## DECISION OF THE HEARINGS OFFICER

**CONDITIONAL USE / CLASS 3 SITE PLAN REVIEW / CLASS 2 ADJUSTMENT .  
CLASS 1 DESIGN REVIEW CASE NO.: CU-SPR-ADJ-DR23-04**

**SUMMARY:** Development of the second phase of the East Park Apartments, including an additional four buildings containing 42 dwelling units.

**EAST PARK APARTMENTS PH.2**

**SITE PLAN**

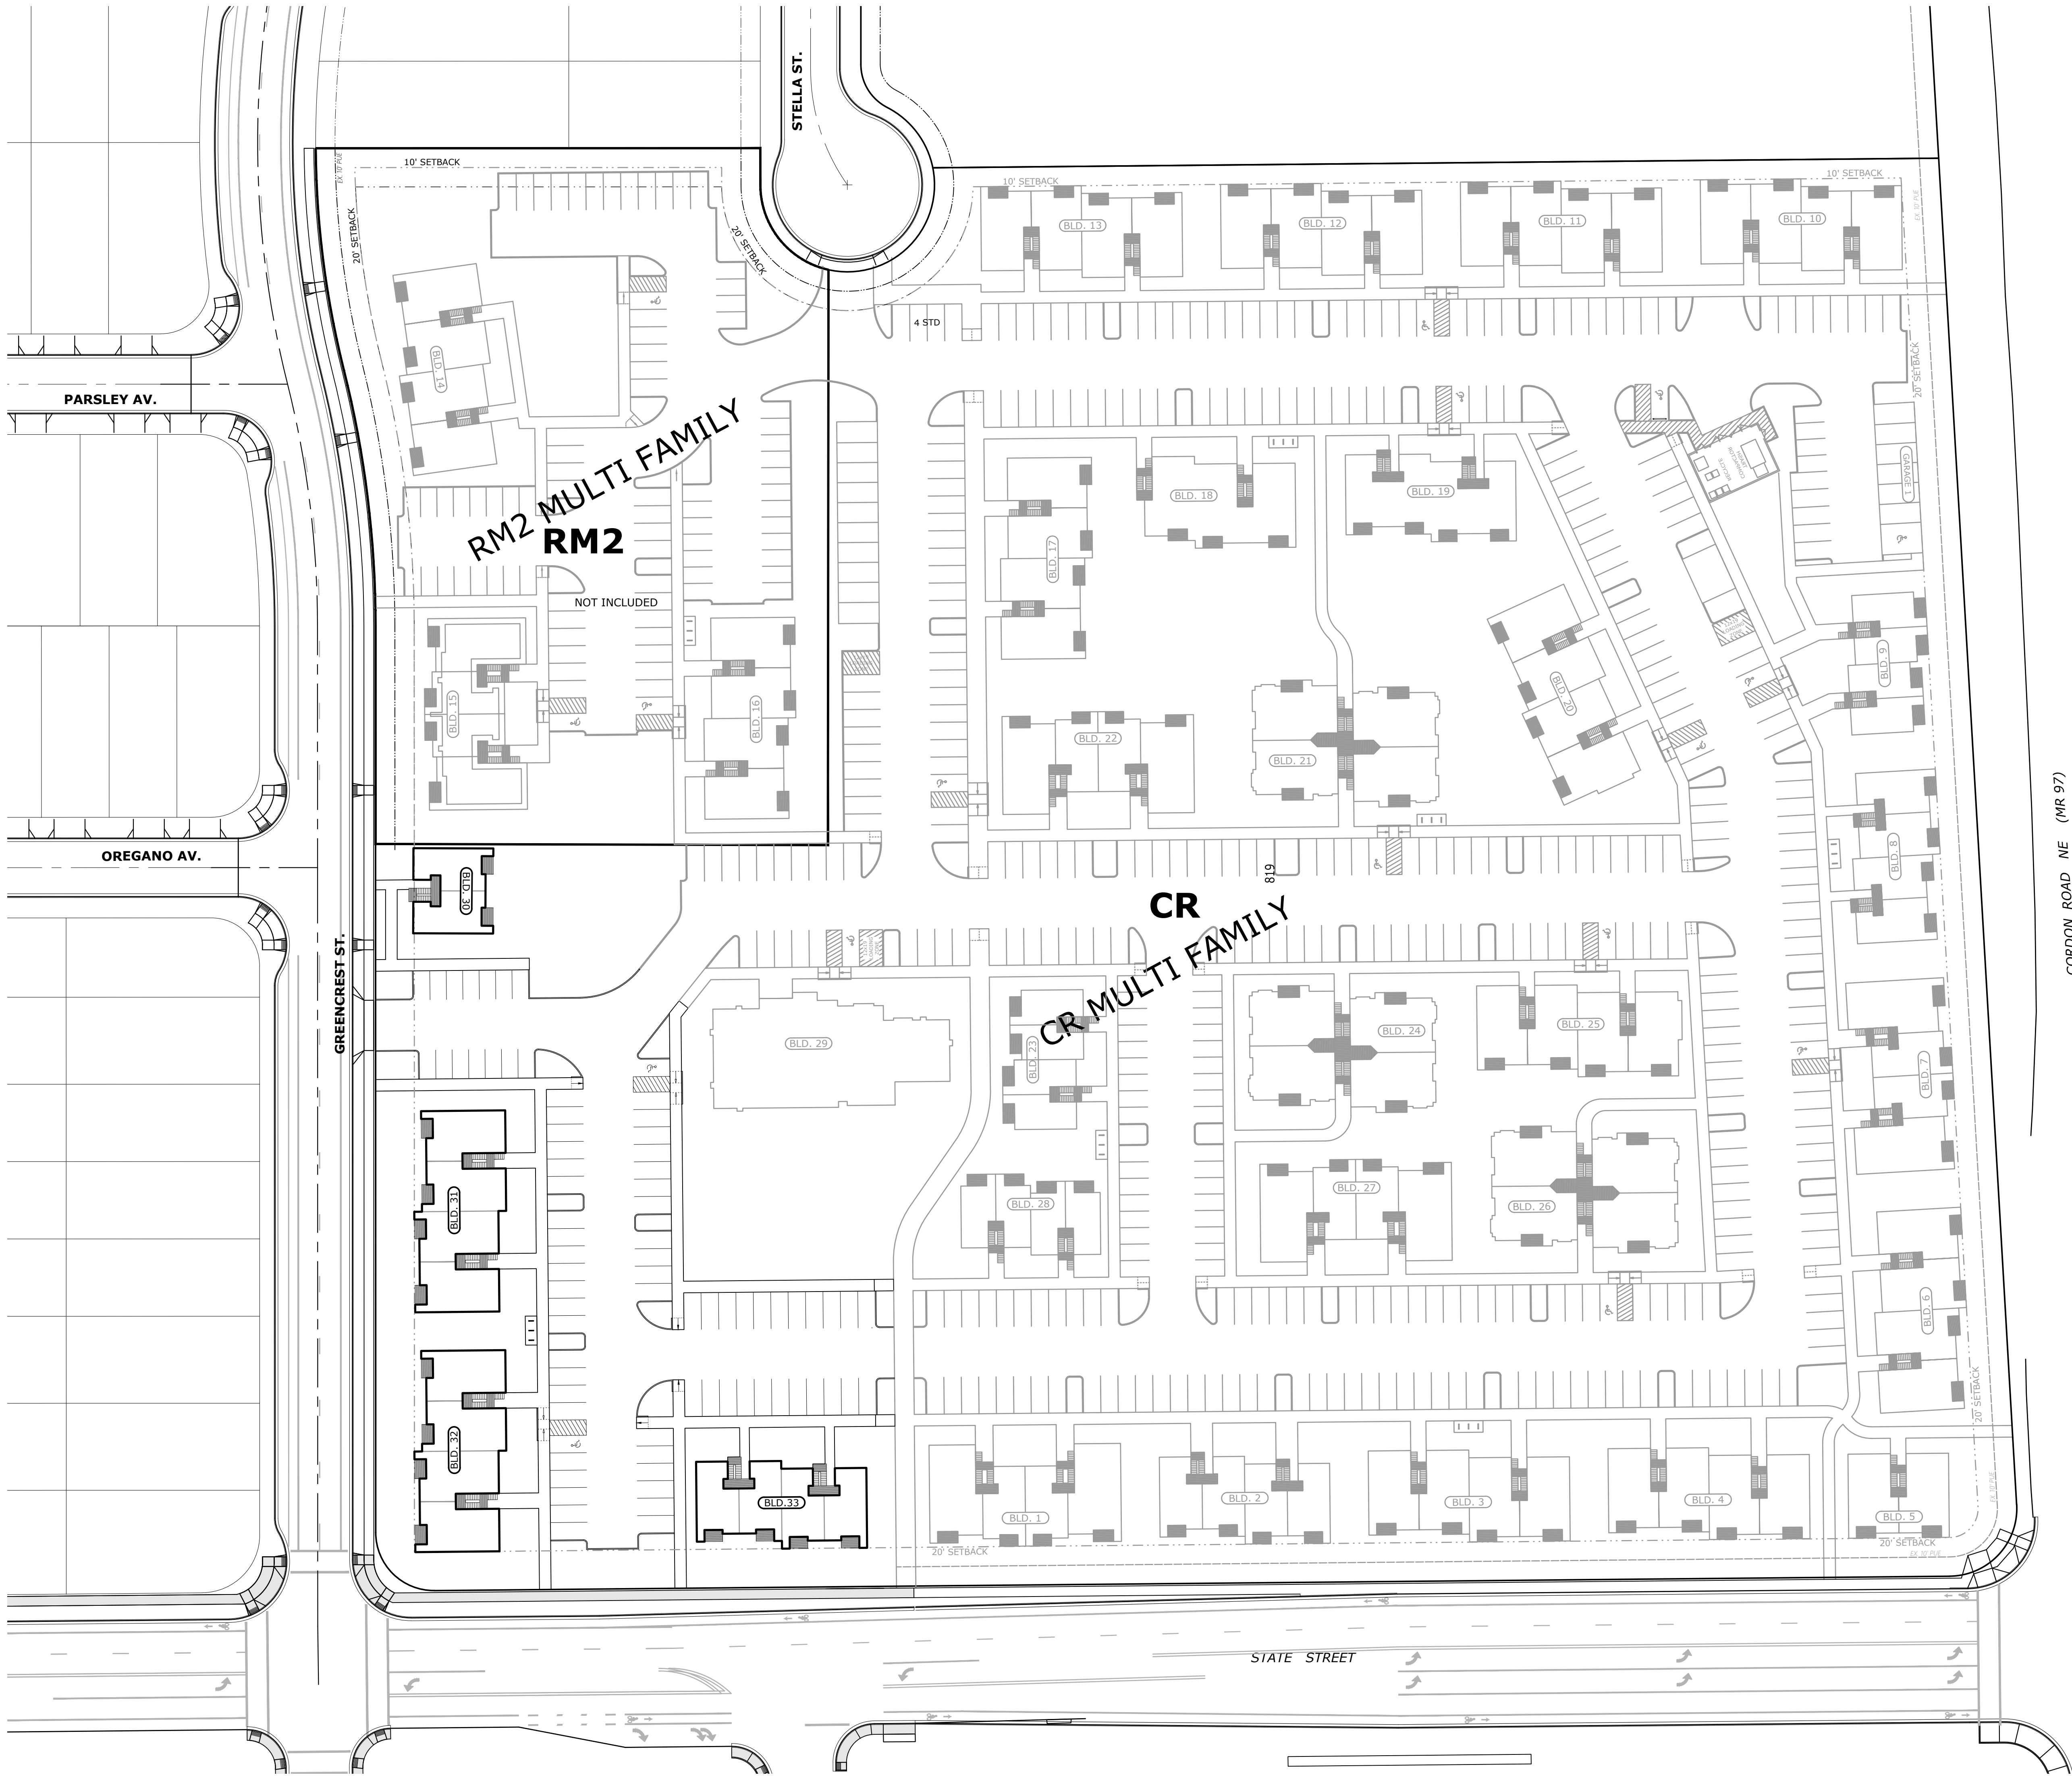
**Finding:** The property line separating the subject property from the previously approved 36-unit multi-family residential use may not be platted, as Lots 350 and 351 may be combined. The site plan indicates that Building 30 has a setback of approximately 10 feet to the north, in compliance with the setback standard of the CR zone.

**Finding:** The site plan indicates that Buildings 32 and 33 are set back 20 feet, and the nearest vehicle use area is set back approximately 20 feet from State Street in compliance with the setback standard of the CR zone.

**Finding:** The property line separating the subject property from the previously approved 291-unit multi-family residential use may not be platted, as Lots 350 and 351 may be combined. The site plan indicates that Building 33 has a setback of approximately 15 feet, and the vehicle use area has a setback of approximately 10 feet, in compliance with the setback standard of the CR zone.

**Finding:** The site plan indicates that Buildings 30, 31, and 32 are set back 20 feet and the nearest vehicle use area is set back approximately 20 feet from Greencrest Street NE, in compliance with the setback standard of the CR zone.

**Finding:** The total area of the subject property is approximately 1.74 acres (75,708 square feet), requiring a minimum of 11,356 square feet of landscape area ( $75,708 \times 0.15 = 11,356.2$ ). The site plan indicates that approximately 26,115 square feet (34.5%) of the development site will be landscaped, exceeding the minimum requirement.

**Finding:** The site plan indicates that a minimum of five feet of separation will be provided between the proposed vehicle use areas and all proposed buildings, in compliance with this section.

**Finding:** The parking area contains 77 parking spaces, requiring 6 planter bays at least nine feet in width. The landscaping plan indicates that at least 13 planter bays, nine feet in width and each with a canopy tree, will be provided. There are no rows of parking greater than 12 spaces without a landscape planter bay. A minimum of one canopy tree is provided every 50 feet around the perimeter of the parking areas in compliance with this standard.

- Condition 8:** Proposed Buildings 30-32 must comply with the direct pedestrian access standard of SRC 702.020(e)(5) along Greencrest Street NE.
- Condition 9:** The adjusted development standards, as approved in this zoning adjustment, will only apply to the specific development proposal shown in the site plan. Any future development, beyond what is shown in the site plan, must conform to all applicable development standards of the UDC, unless adjusted through a future land use action.

**Condition 9:** The adjusted development standards, as approved in this zoning adjustment, will only apply to the specific development proposal shown in the site plan. Any future development, beyond what is shown in the site plan, must conform to all applicable development standards of the UDC, unless adjusted through a future land use action.

East Park  
Apartments  
Phase 2

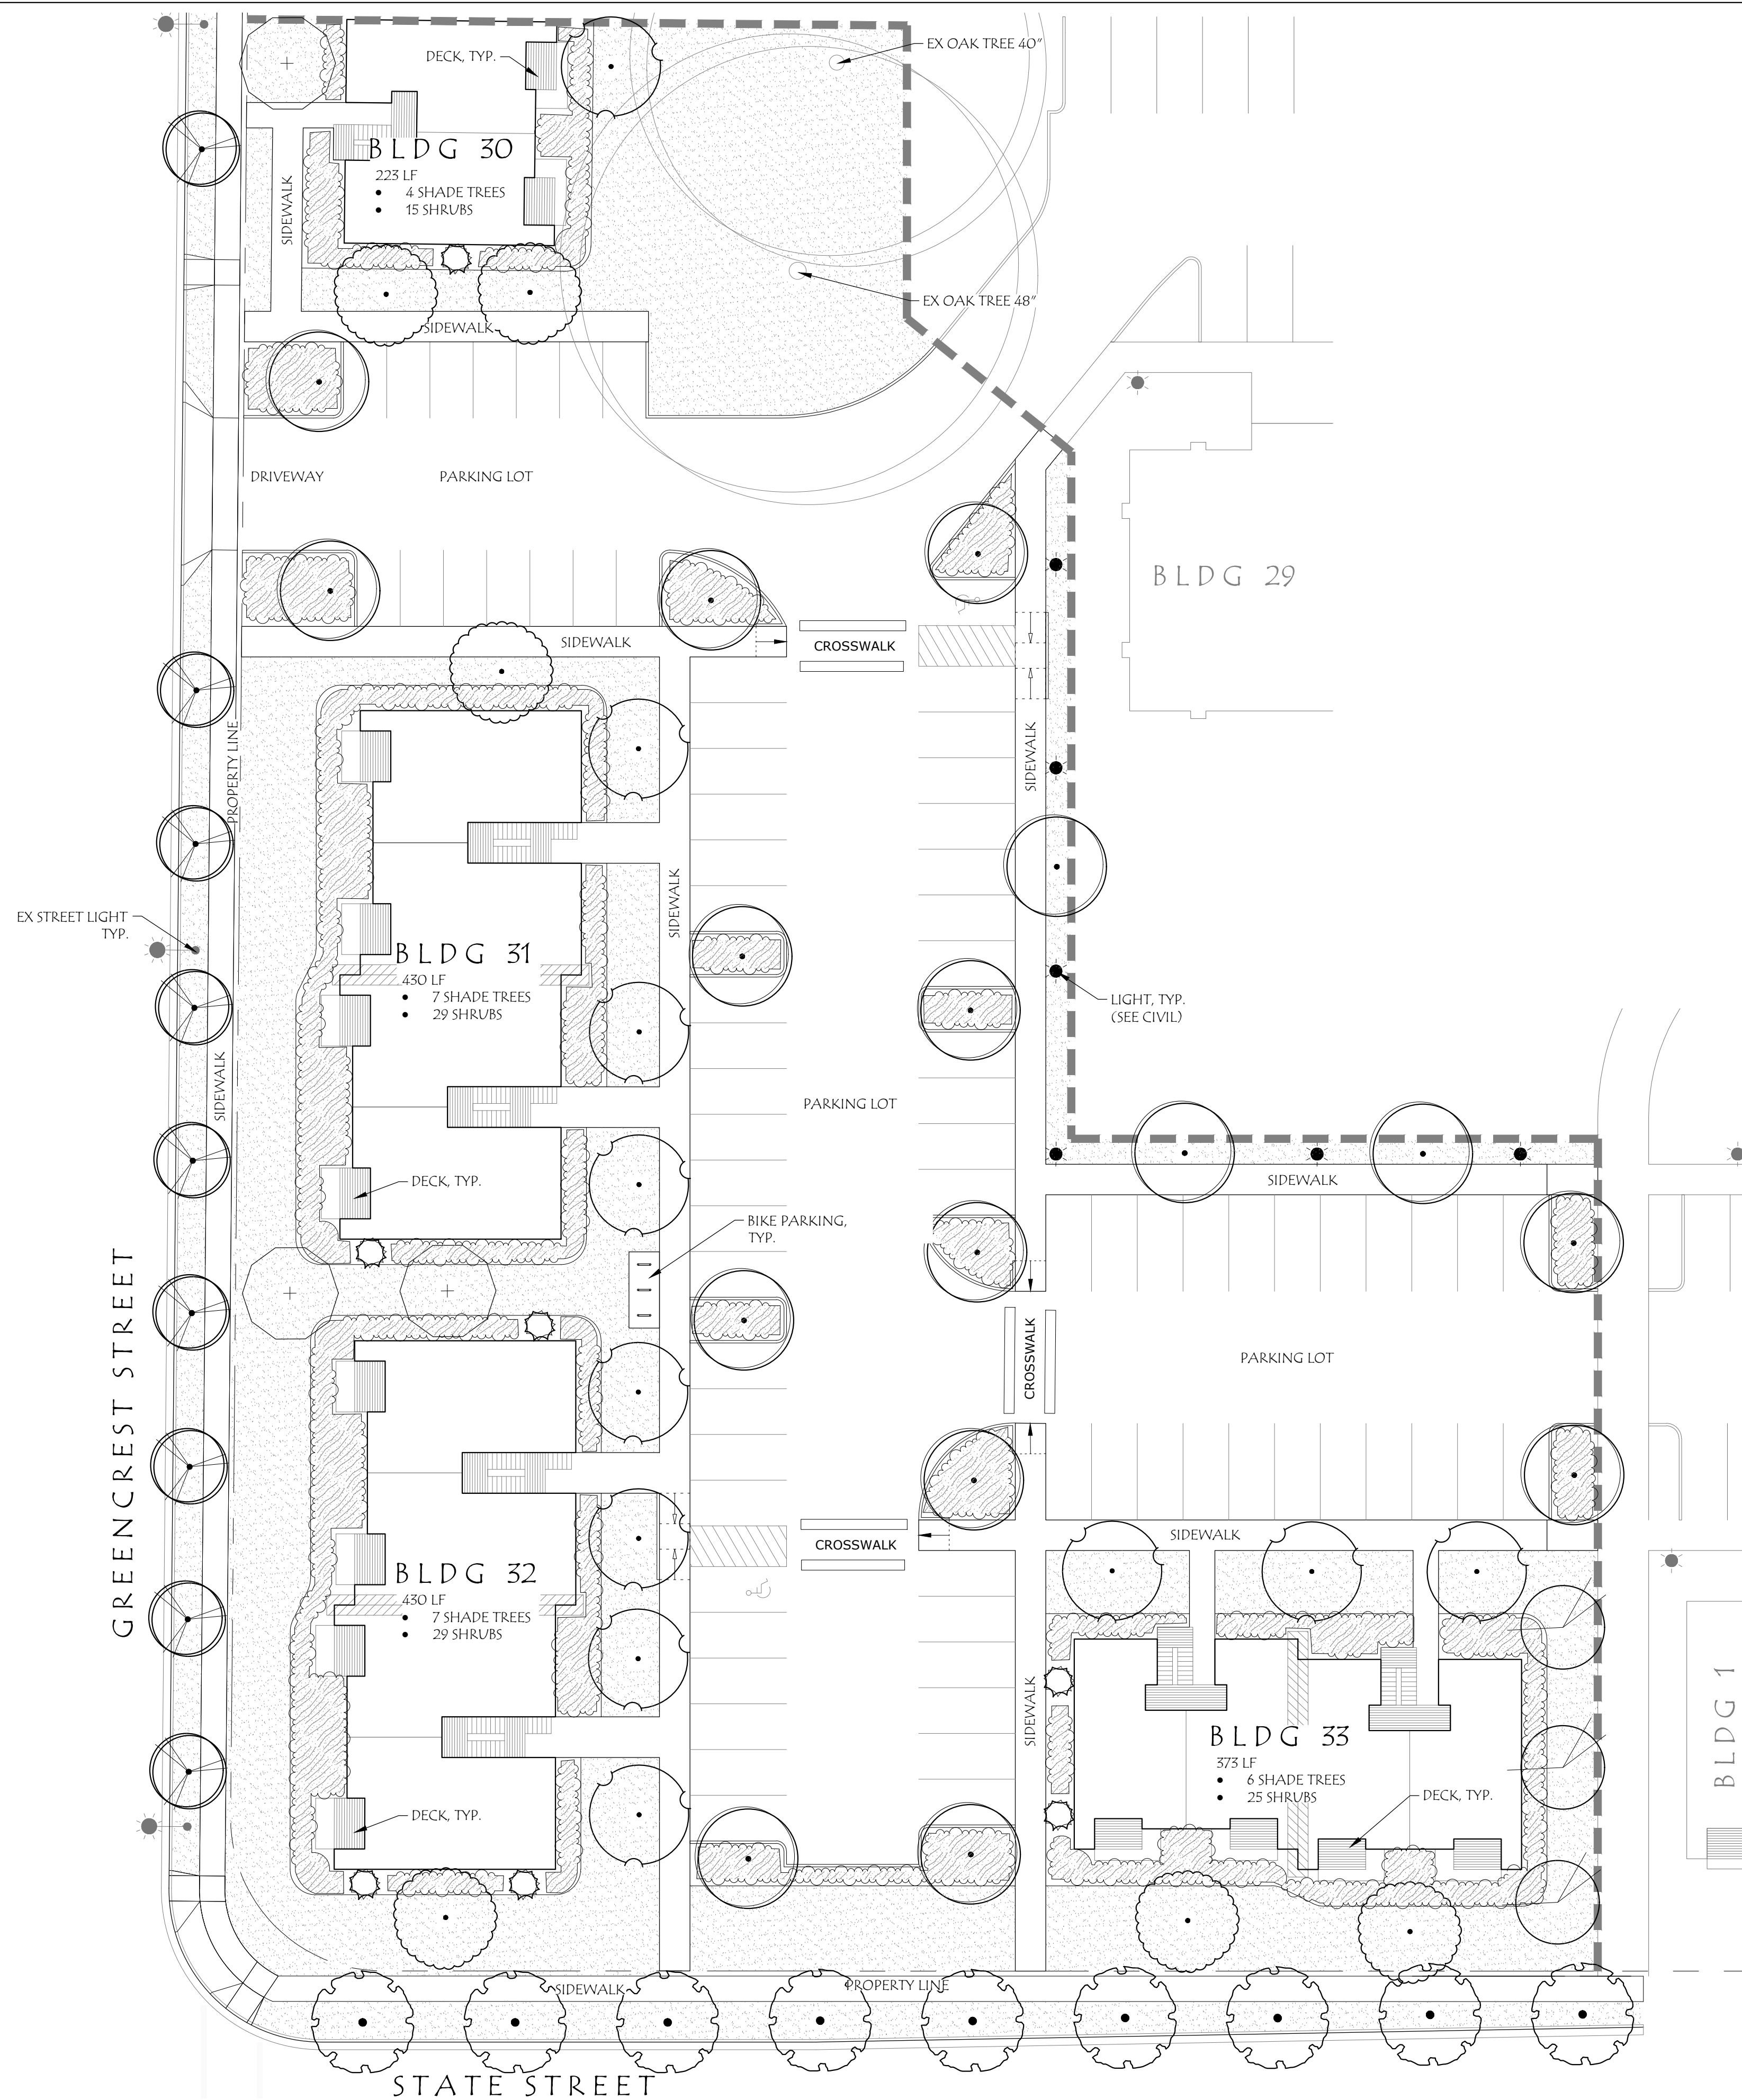
**Finding:** The proposed development occurs on a portion of the subject property that is approximately 1.74 acres in size (75,708 square feet) requiring a minimum of 38 trees ( $75,708 / 2,000 = 37.9$ ). The preliminary landscape plan indicates that 46 trees will be provided for this portion of the development site, exceeding the minimum requirement.

**Finding:** The landscaping plan provided indicates that at least two plant units will be installed at each shared entrance.

**Finding:** The landscaping plan provided indicates that at least ten plant units of trees per 60 linear feet of exterior building wall are to be planted within 25 feet on each side of the proposed buildings.

**Finding:** The landscaping plan provided indicates that at least one plant unit of shrubs per 15 linear feet are to be planted on each side of the proposed buildings.
